CORRIGENDUM- 05

PROJECT	:	(3X200 MW+3x500 MW) RAMAGUNDAM STAGE-I & II FGD
PACKAGE	:	GYPSUM DEWATERING SYSTEM
TENDER ENQUIRY NO	:	PE/PG/RGM/E-6515/2020 Dt. 05/09/2020
SUBJECT	:	REGARDING REPLY OF PRE BID QUERY

PRE BID CLARIFICATIONS - 1

TITLE:
GA OF CONVEYOR- GBC 1A/1B

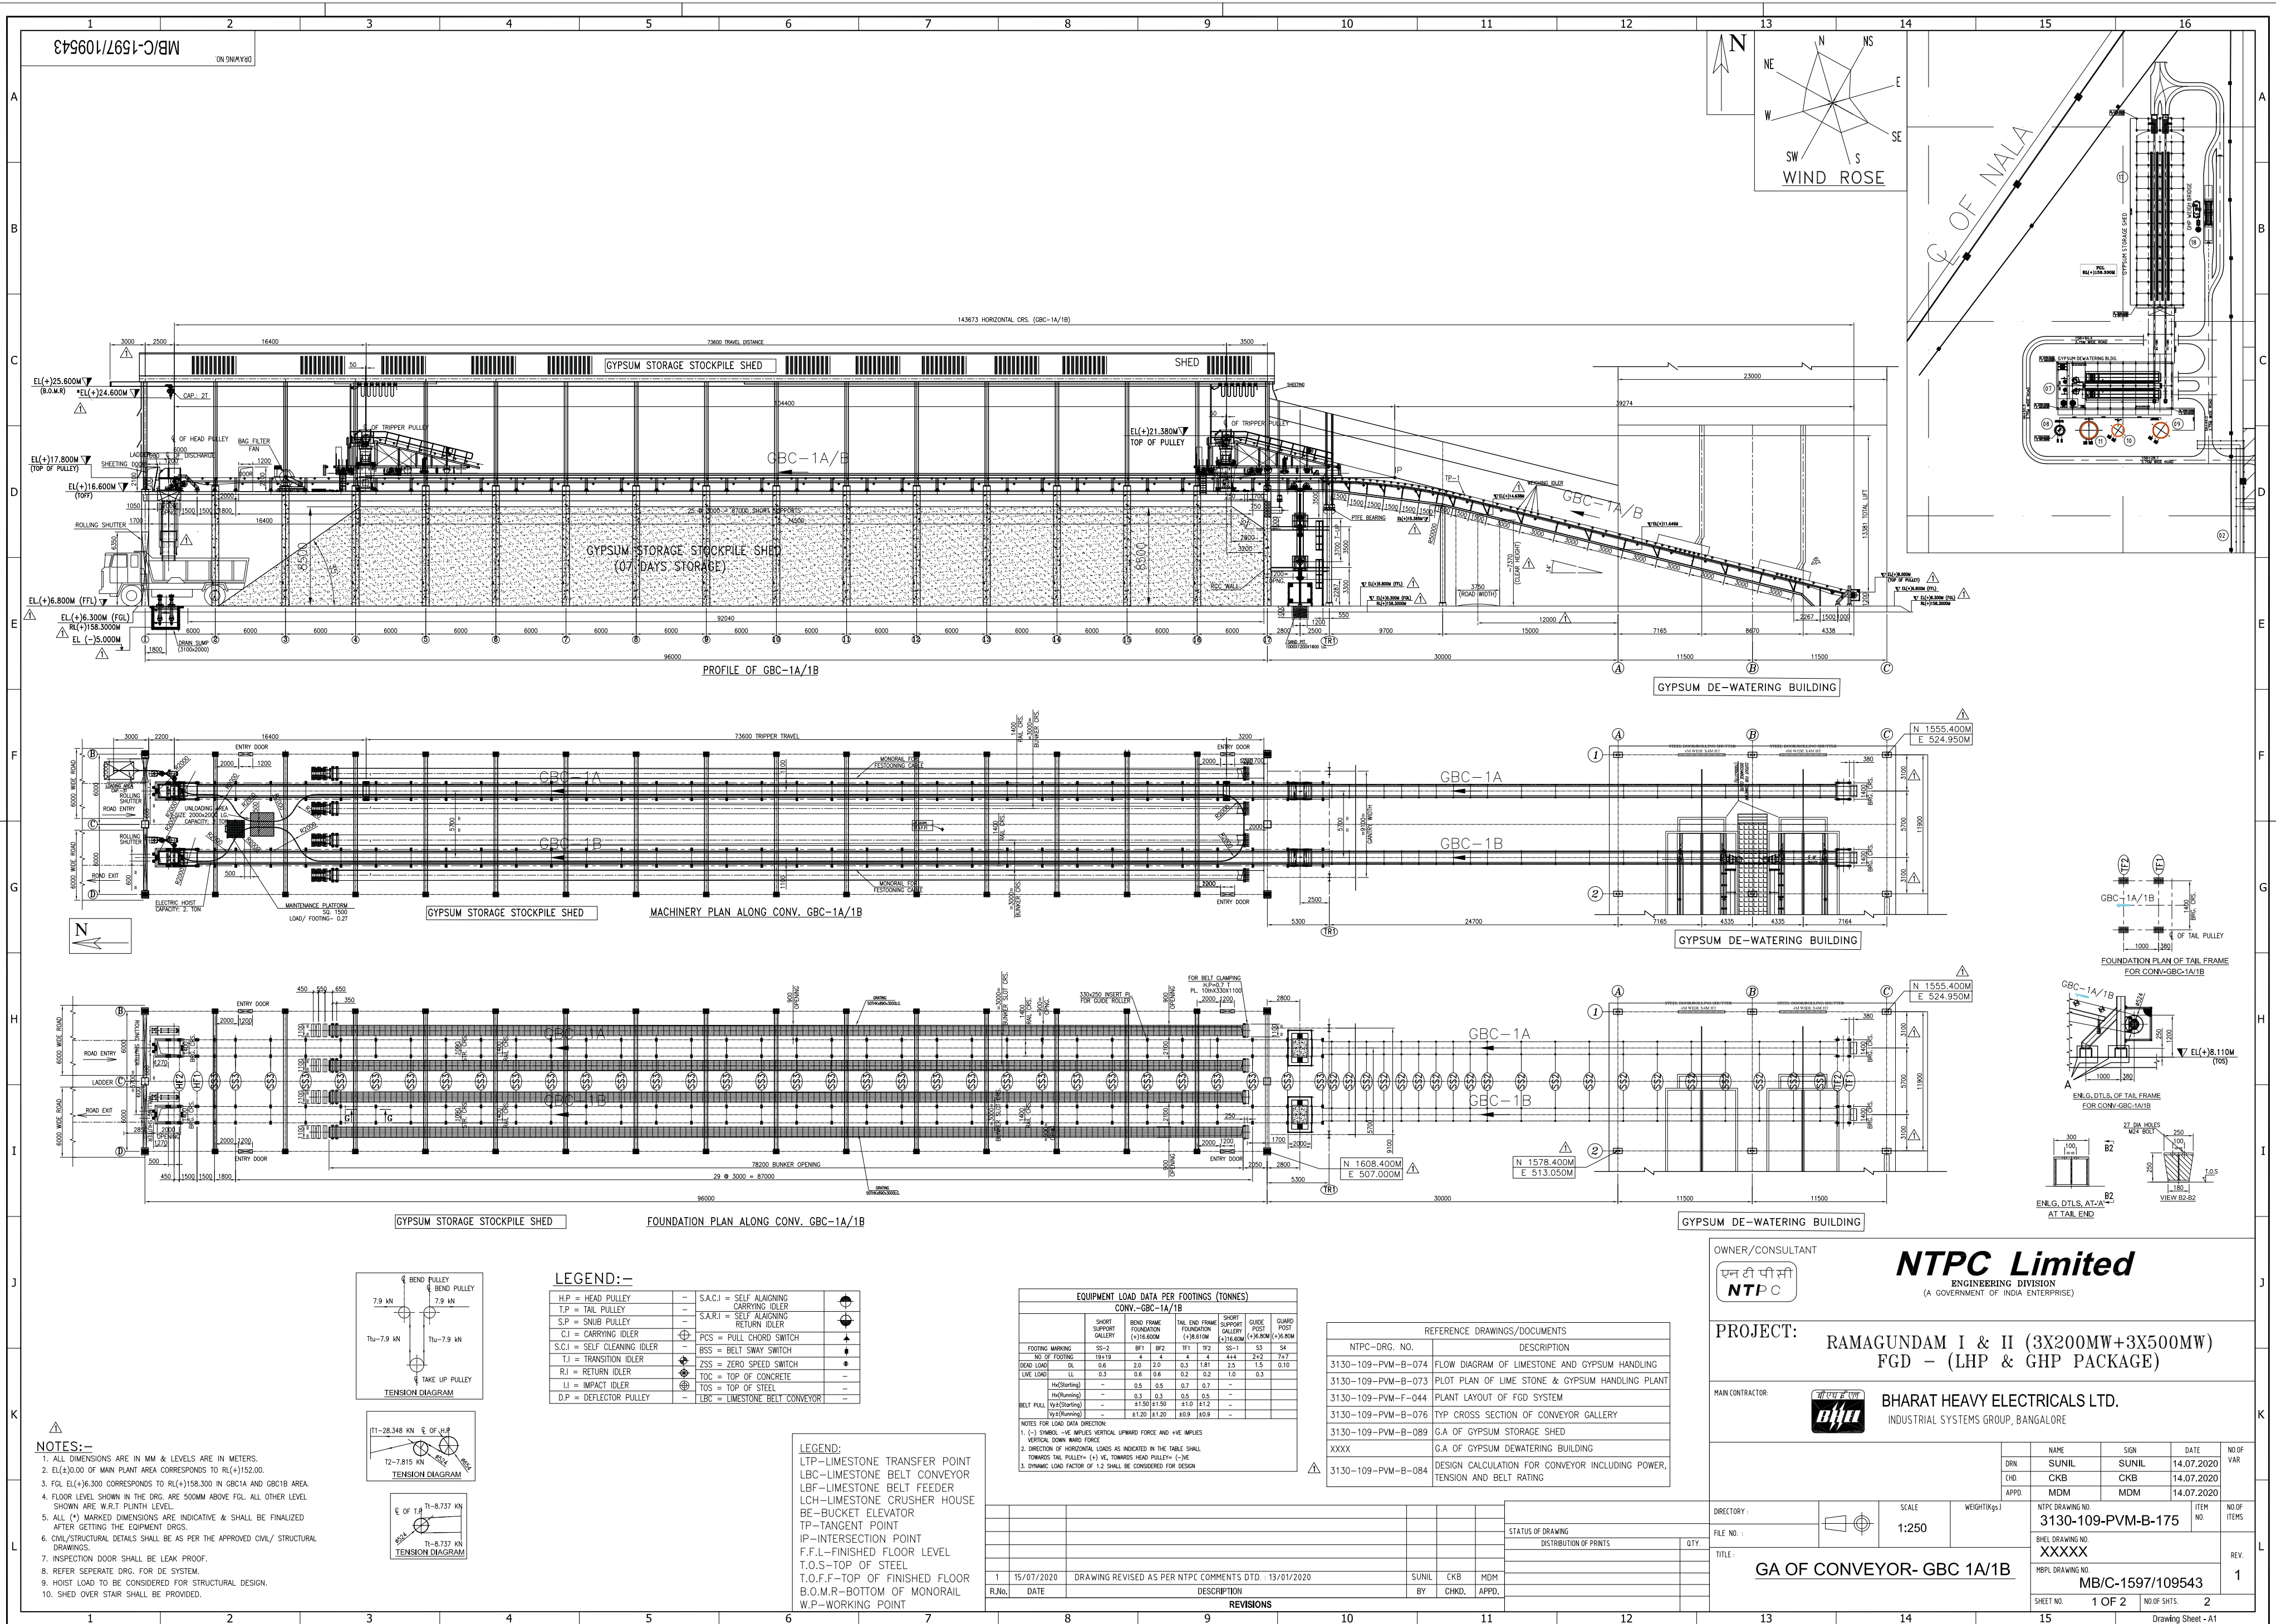
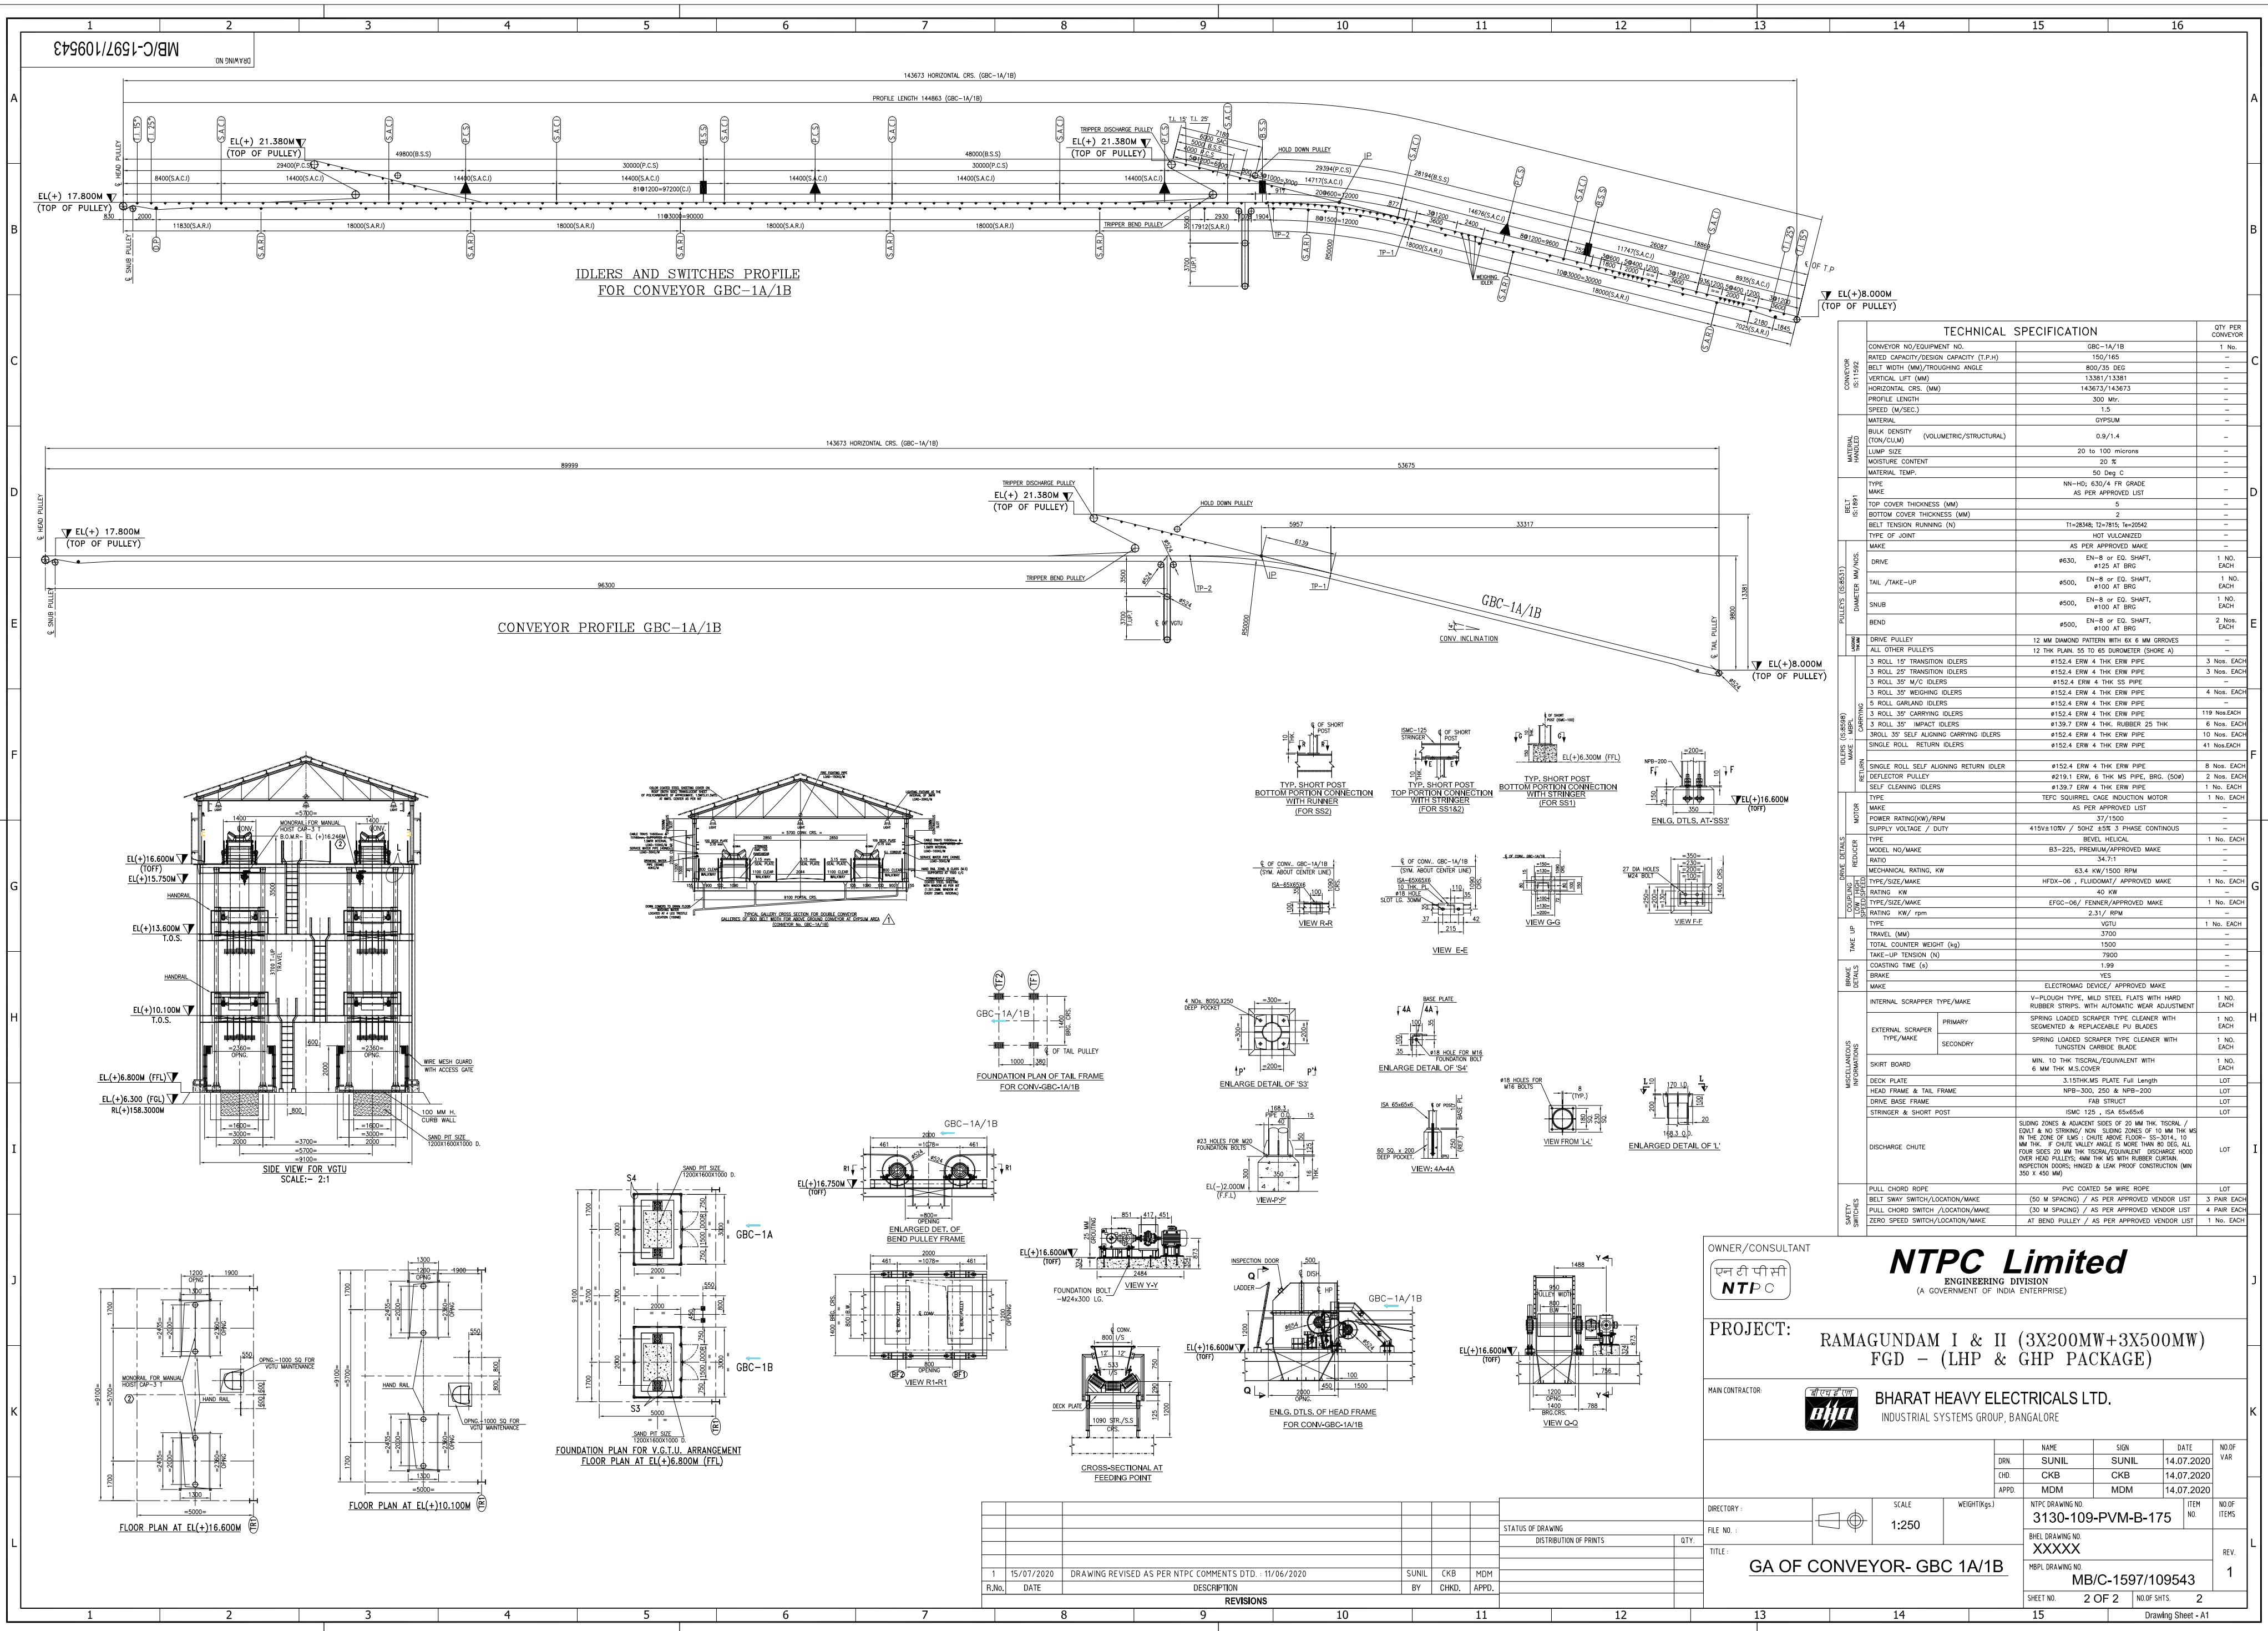
45		412 of 537	Elevation view of conveyor is not provided in layout	Client to provide the same	Extracts of elevation view of conveyor attached for reference as Annexure-B to this pre-bid clarifications.

TITLE:
P & ID-GYPSUM DE WATERING SYSTEM
(FILTRATE WATER TANK)

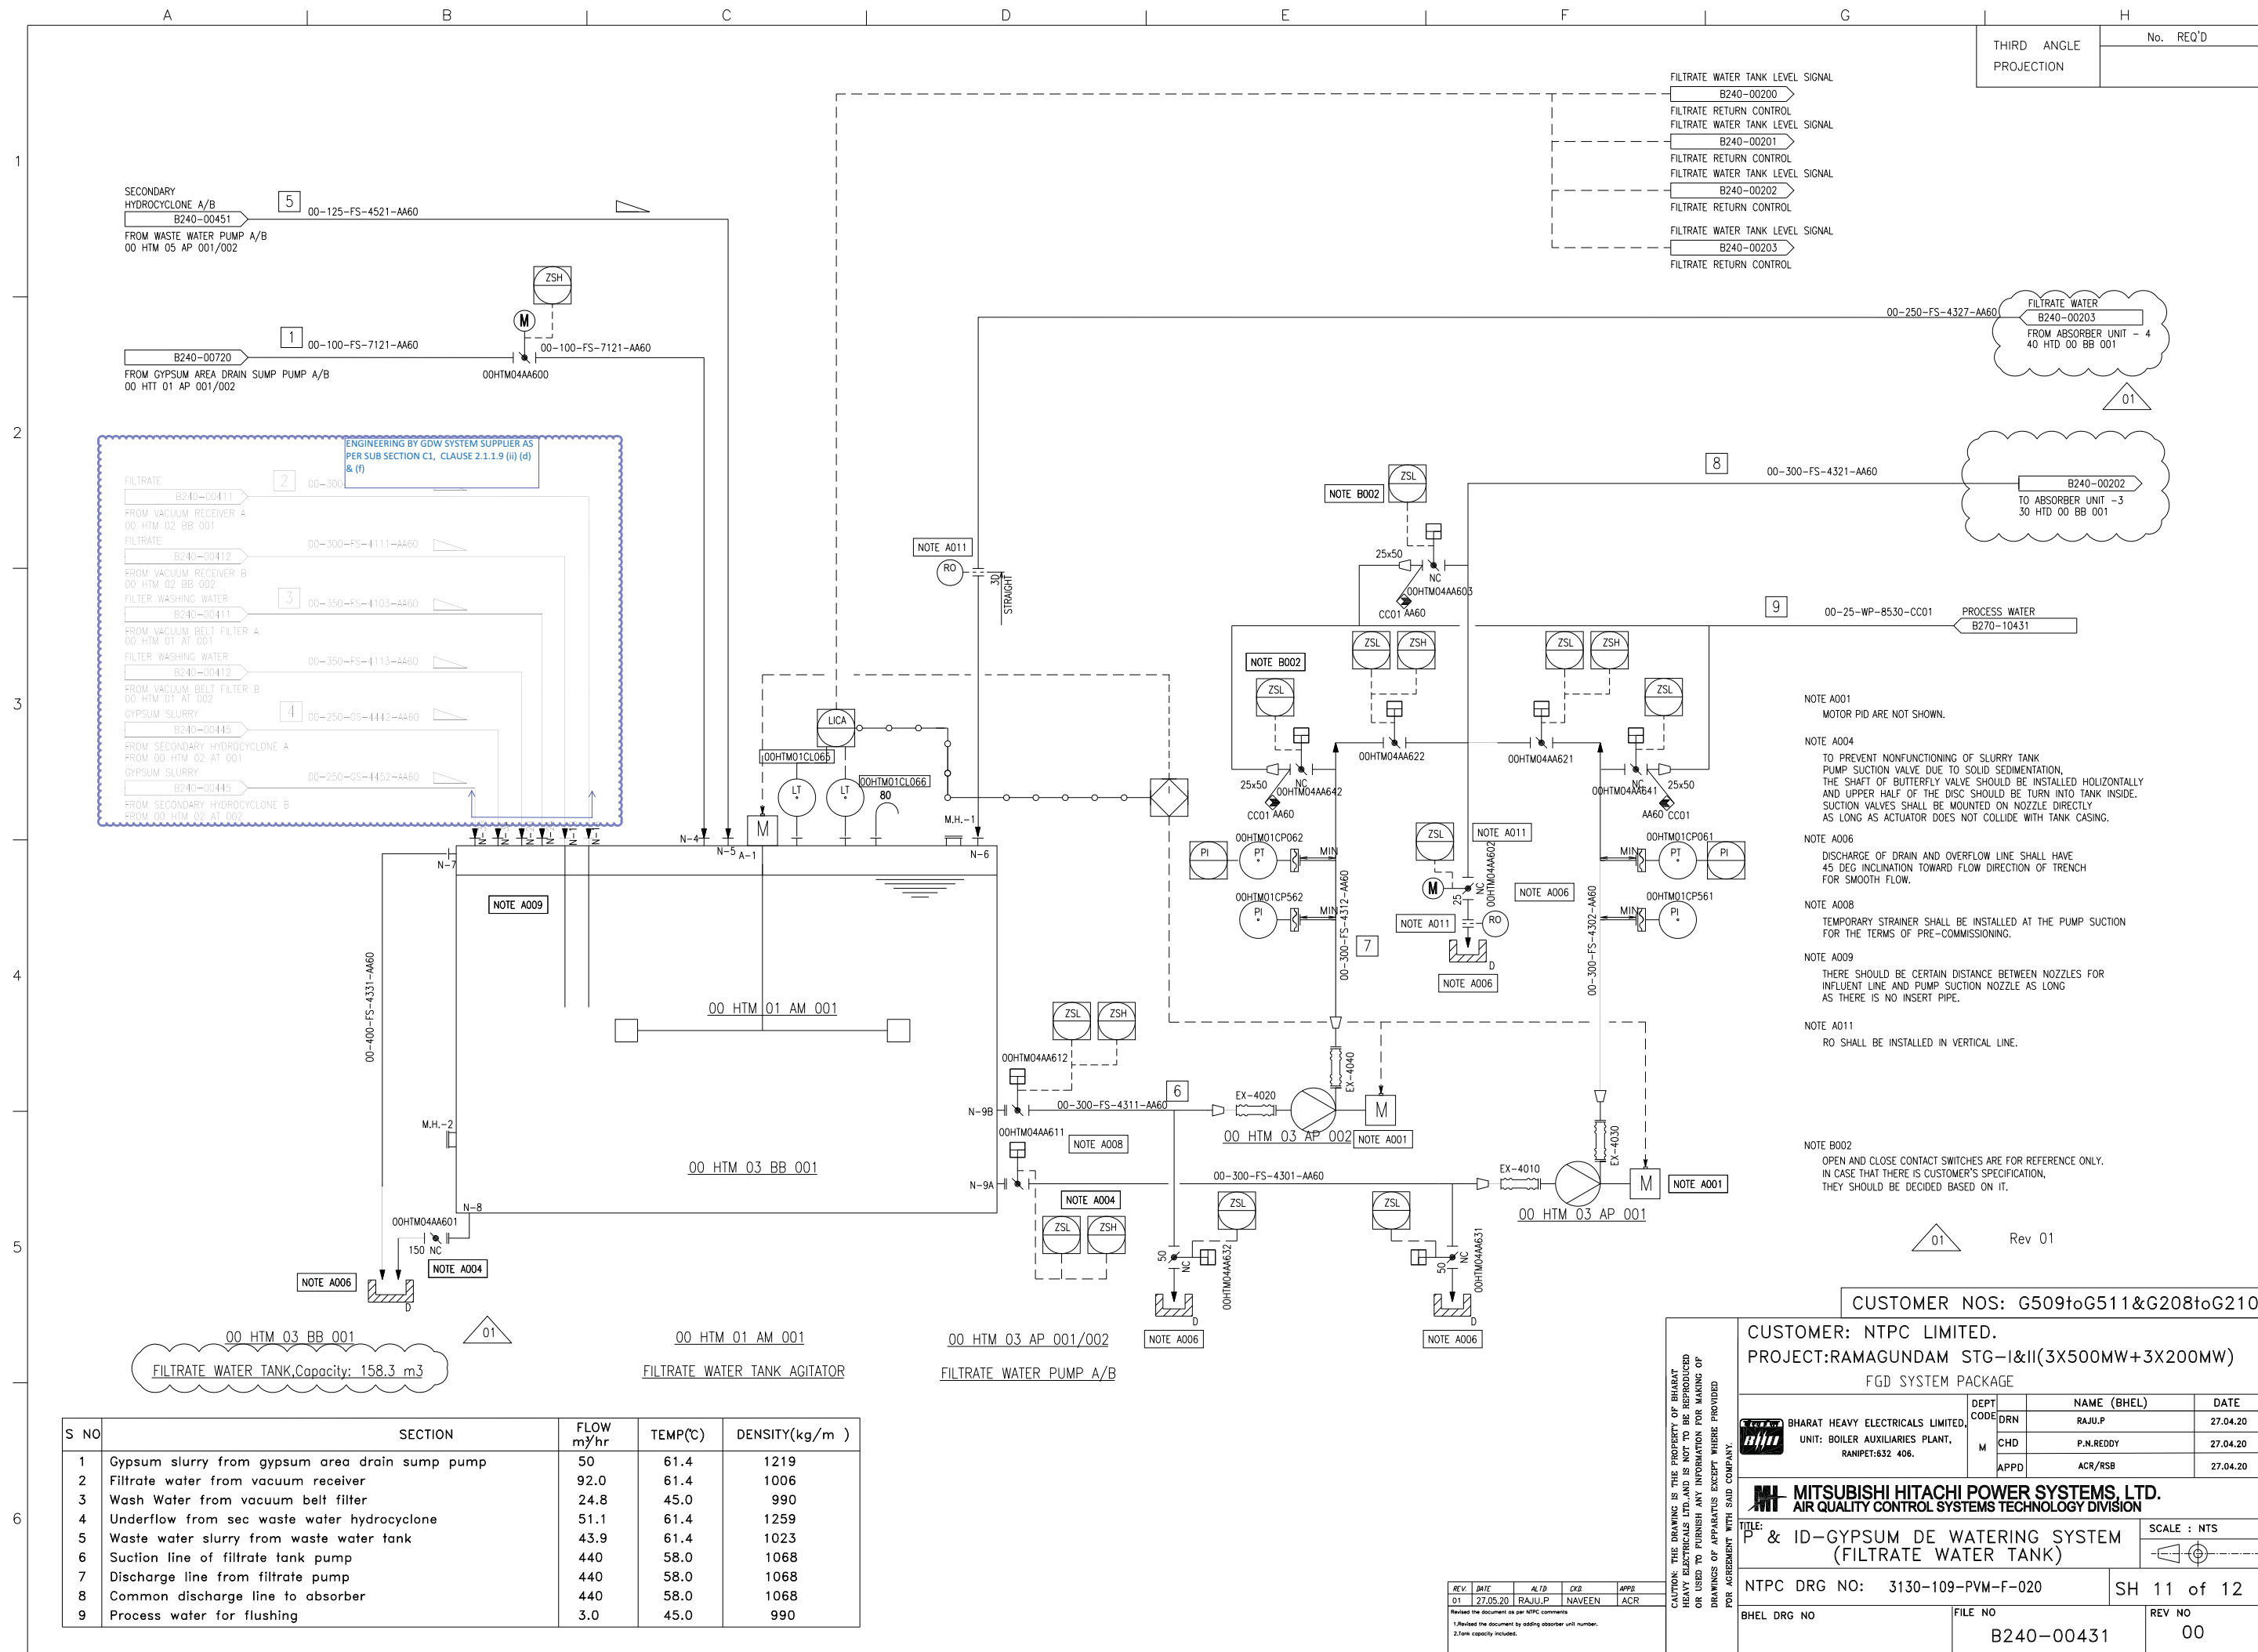
Feed slurry solids composition will be shared during detail engineering.
75					P&IDs for Bidder's scope of Engineering as per Clause 2.1.1.9 (ii) (d), (e) & (f) are enclosed as Annexure-C to this pre-bid clarifications.
